SUBJECT : Hyundai ImageQuest Co., Ltd.
FCC ID: PJIL17A00000
Class II Permissive Change
Orig. Grant Date : March 29, 2005

Transmitted herewith, on behalf of Hyundai ImageQuest Co., Ltd. is an application for a Class II Permissive Change Certification of the following 17-inch LCD Monitor:

FCC ID : PJIL17A00000
Model/TYPE : B70D/L17A00000

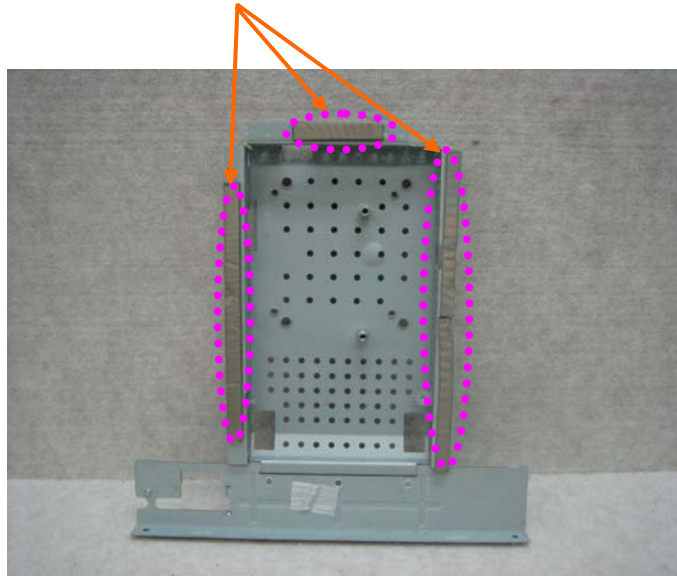
1. Attach a gasket on the main frame to contact the lcd panel

2. Attach aluminum tape on the Rear frame.
